Certificate of Appropriateness

2633 - 2651 N. DOWNER AV. Downer Avenue HD

Date issued 9/18/2018 PTS ID 114632 COA: masonry and window repairs

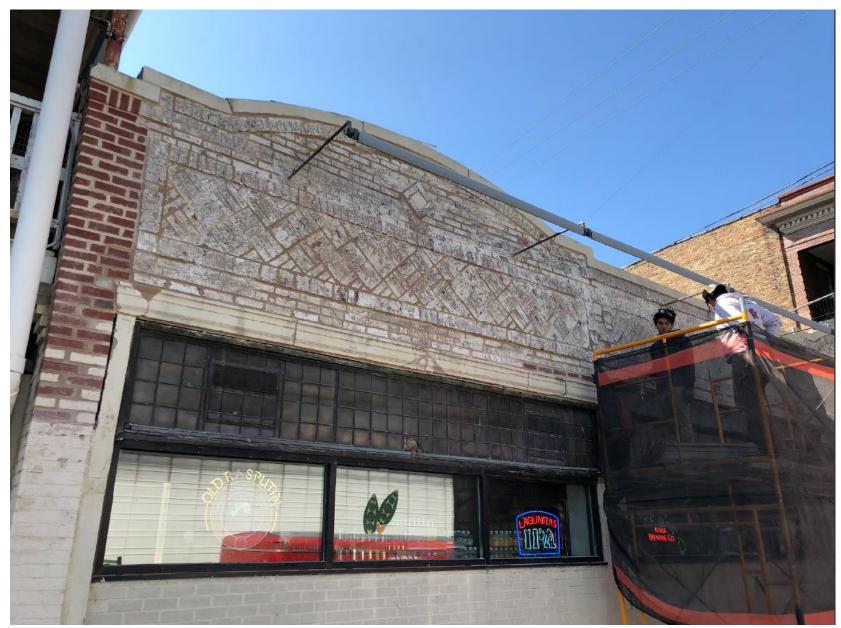
Description of work Remove secondary siding from upper half of Park Place elevation (stucco and wood sheet).

Repoint underlying masonry.

Restore prismastic glass transom with new panes and general repairs to caming.

It is assumed that there is not enough original mortar remaining to determine any historic information other than joint width. Joint profile and mortar color are left to the mason's best judgment as long as a mortar that is no harder than Type N is used.

The compressive strength of the repointing mortar shall be equal or less than the compressive strength of the original mortar and surrounding brick or stone. The replacement mortar shall contain approximately the same ingredient proportions of the original mortar. Mortar that is too hard is subject to premature failure and could damage the masonry. No joint of a width less than 3/8" may be cleaned of damaged/decomposed mortar with power disc grinders. No over-cutting of the joints is permitted. Remove decomposed mortar back into the wall 2.5 times the height of the joint before repointing.

New brick must match as closely as possible the color texture, size, and finish of the original brick.
